Re: Cabrini of Westchester – Responses to Village Parking Consultant Comments
Premises: 115 Broadway, Dobbs Ferry, New York (003.120-104-1)

RE: Cabrini of Westchester – Application for Site Plan Approval – Parking Lot (25 Spaces)
Responses to BFJ Planning Letter Dated May 19, 2020
Section 003.120, Block 104, Lot 1
115 Broadway, Dobbs Ferry, NY

EXHIBIT A

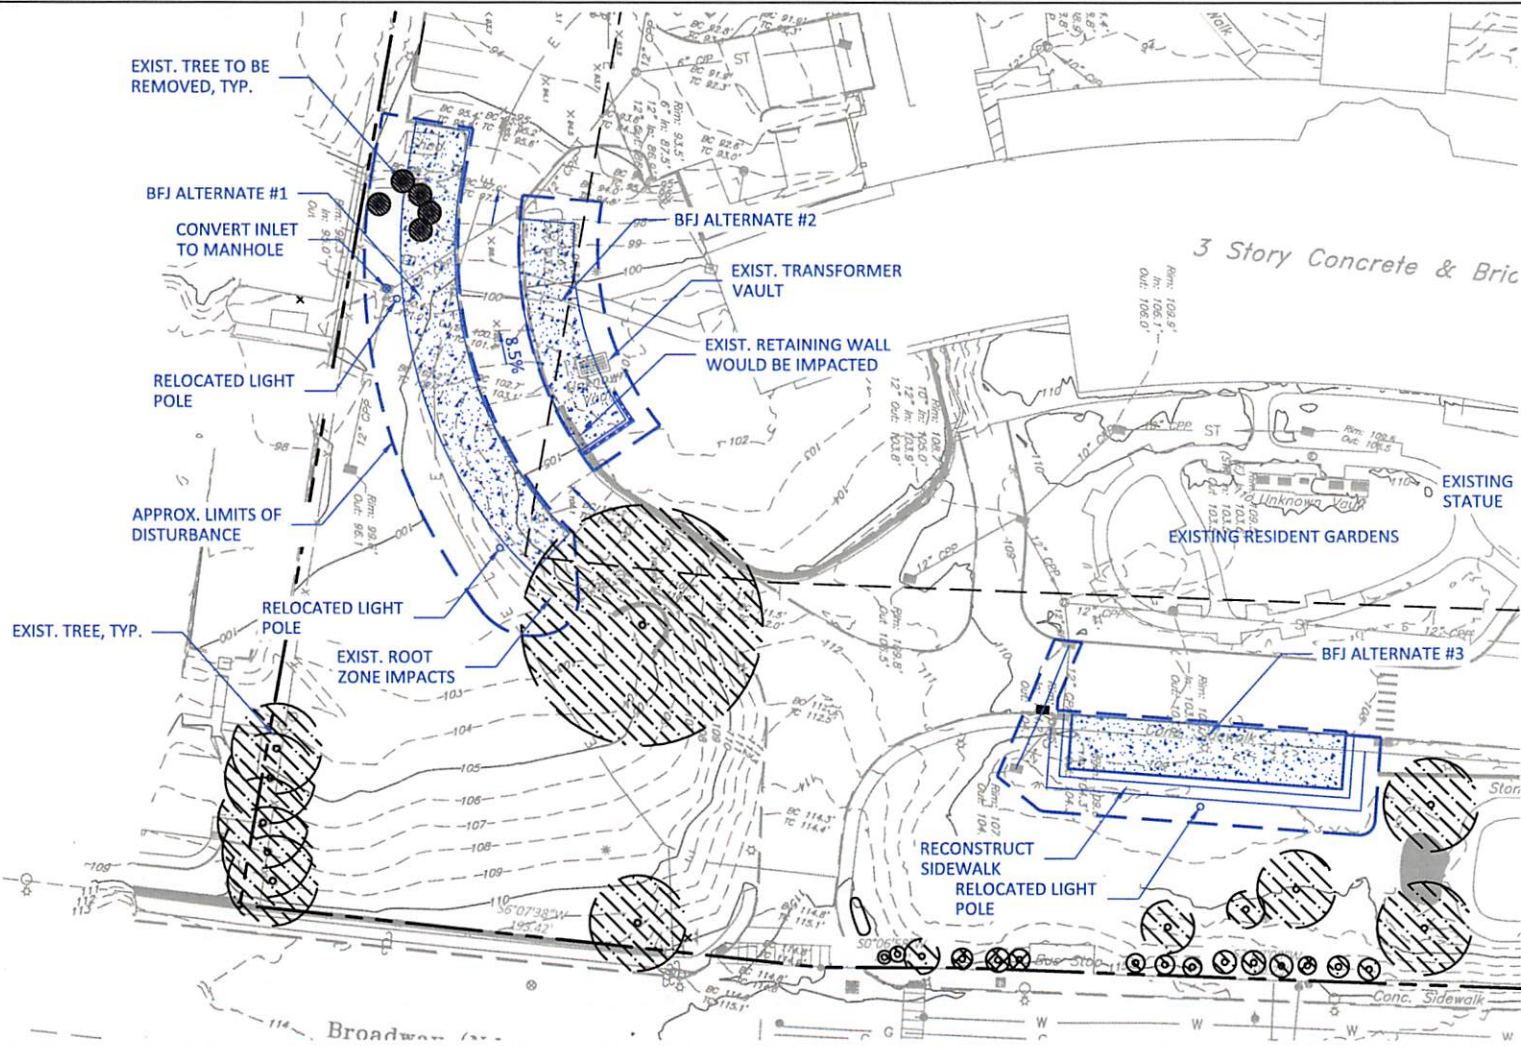
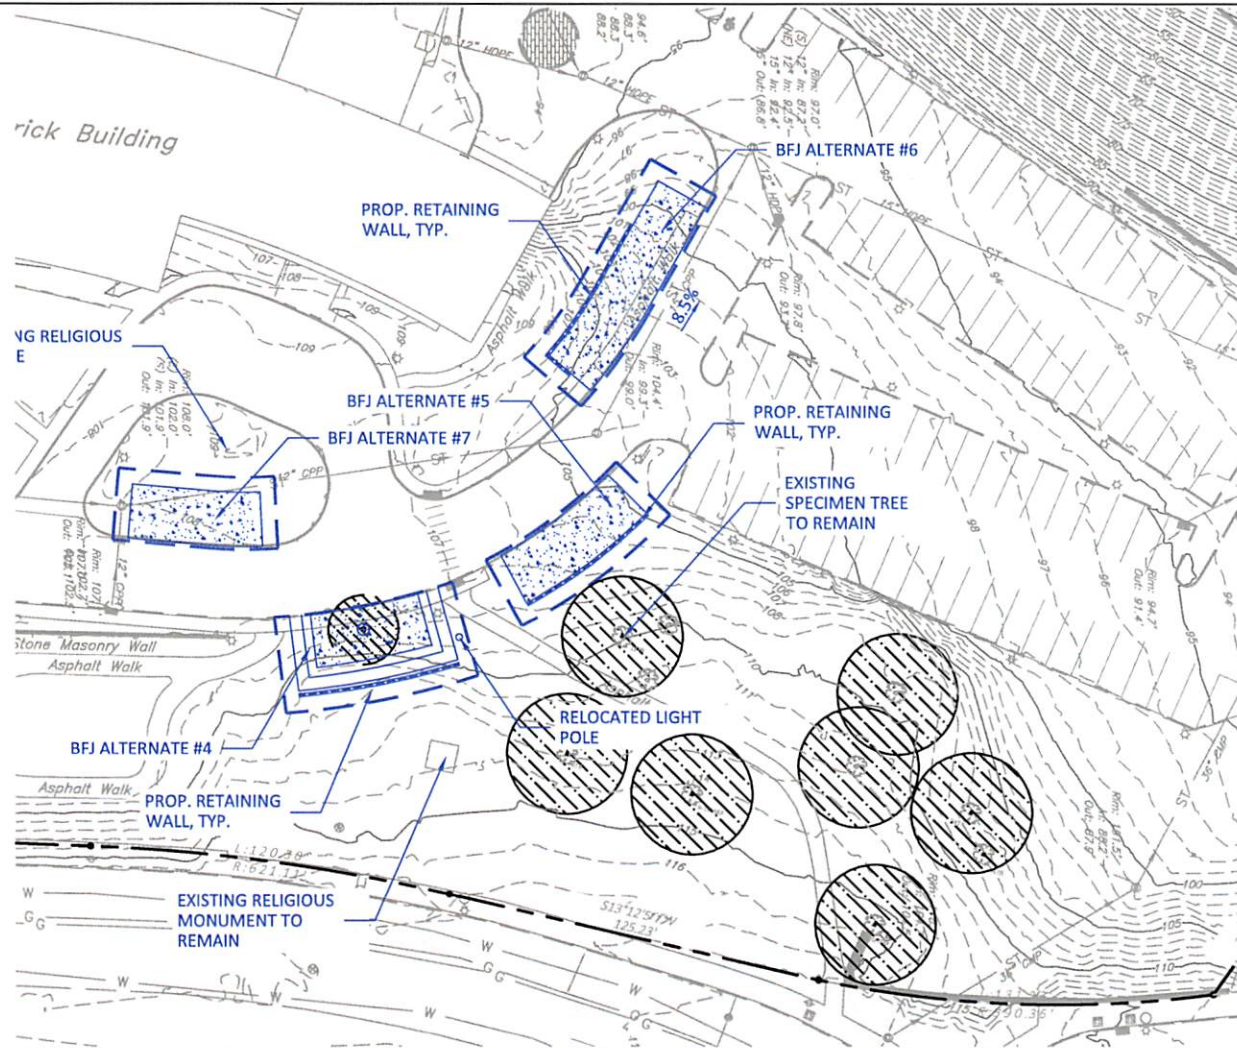
- 2) *BFJ Comment:* If TDM actions are not deemed feasible and the Village allows an increase in parking supply on the Cabrini site, we recommend that alternate locations be chosen that do not destroy the aesthetic quality of the frontage of the southeast corner. We believe that perpendicular parking spaces can be provided safely at the locations indicated in Exhibit 2 that are cost effective, need significantly less pavement per added parking space and have minimal aesthetic impact.

PDE/Applicant Comments Regarding BFJ Alternate #1:

- The existing road grade is an average of 8.5%. It is neither desirable nor good practice to construct parking on slopes in excess of 5%. §300-48.C(4) of the Village Code requires a maximum grade of 5% in parking areas.

- §300-48.D(3) of the Village Code requires a two way aisles width of 24 feet. The existing driveway width is 20-21 feet wide. Widening of the driveway would result in a net increase in impervious surface area of approximately 600 s.f.
- The construction of this alternative would result in impacts to the existing root zone of the 54" tree to be preserved.
- This BFJ Planning proposed parking alternative would sit at an elevation of approximately 106' and would present the potential to obstruct horizon line views to the west from Broadway.

PDE/Applicant Comments Regarding BFJ Alternate #2

- The existing road grade is an average of 8.5%. It is neither desirable nor good practice to construct parking with slopes in excess of 5%. §300-48.C(4) of the Village Code requires a maximum grade of 5% in parking areas.

- §300-48.D(3) of the Village Code requires a two way aisles width of 24 feet. The existing driveway width is 20-21 feet wide. Widening of the driveway would result in a net increase in impervious surface area of approximately 600 s.f.

- As noted previously to this Board and the Planning Board, the existing electrical transformer vault is the primary service to the existing building is located in this area. The Consolidated Edison publication entitled "Transformer Vault Placement and Space Requirements", dated April 2006 indicates that transformer vaults are to be placed in sidewalk areas and further states that if vaults are located in a driveway area, then the customer must pay incremental Con Edison costs which would include special grating designs, increased maintenance, etc. Relocation and/or modification of the existing transformer vault would cost an estimated \$100,000 to \$150,000.

PDE/Applicant Comments Regarding BFJ Alternate #3

- The objective of the proposed parking area is to provide additional staff parking in the south parking lot within a safe and reasonable walking distance to the employee entrance. We understand that this existing need is only amplified in light of the current COVID-19 pandemic. By providing additional staff parking in the south lot, the north lot would be freed up for guest and visitors.

- The proposed parking area would have direct visual and aesthetic impacts from the perspective of the garden area along the front of the existing building. The existing green space that residents and visitors currently experience would be removed.

- The driveway along the frontage of the existing building would be considered the fire apparatus access road and should not be obstructed in any manner, including the parking of vehicles, unless authorized by the Fire Code Official. (Ref: Fire Code of NYS §503.4)

- The existing drainage system would require reconstruction.

PDE/Applicant Comments Regarding BFJ Alternate #4

- The objective of the proposed parking area is to provide additional staff parking in the south parking lot within a reasonable walking distance to the employee entrance. By

- The proposed parking area would have direct visual and aesthetic impacts from the perspective of the entrance and lobby area. The existing green space that residents and visitors currently experience would be removed.
- The driveway along the frontage of the existing building would be considered the fire apparatus access road and should not be obstructed in any manner, including the parking of vehicles, unless authorized by the Fire Code Official. (Ref: Fire Code of NYS §503.4)
- There is an existing religious shrine (constructed in 1924) located approximately 30 feet from the proposed parking area. In order to minimize impacts to the existing religious shrine, it would be necessary to construct a retaining wall at additional cost and impacts to the site.

PDE/Applicant Comments Regarding BFJ Alternate #5

- There is an existing specimen tree located approximately 30 feet from the proposed parking area. In order to minimize impacts to its root zone, it would be necessary to construct a retaining wall at additional cost and impacts to the site.
- The proposed parking area would have direct visual and aesthetic impacts on the entrance and lobby area. The existing green space that residents and visitors currently experience would be removed.

PDE/Applicant Comments Regarding BFJ Alternate #6

- The existing road grade is an average of 8.5%. It is neither desirable nor good practice to construct parking with slopes in excess of 5%. §300-48.C(4) of the Village Code requires a maximum grade of 5% in parking areas.
- The driveway along the frontage of the existing building would be considered the fire apparatus access road and should not be obstructed in any manner, including the parking of vehicles, unless authorized by the Fire Code Official. (Ref: Fire Code of §NYS 503.4)
- The proposed parking area would require a retaining wall due to the grade change and to minimize impacts to the existing building foundation wall and emergency egress door located along the north wall of the existing building.

PDE/Applicant Comments Regarding BFJ Alternate #7

- The existing religious monument/statue in the landscaped island would be impacted and would need to be relocated accordingly at additional cost and impacts to the site.
- The driveway along the frontage of the existing building would be considered the fire apparatus access road and should not be obstructed in any manner, including the parking of vehicles, unless authorized by the Fire Code Official. (Ref: Fire Code of NYS §503.4)
- The parking area would have direct visual and aesthetic impact on the entrance and lobby area. The existing green space that residents and visitors currently experience would be removed.
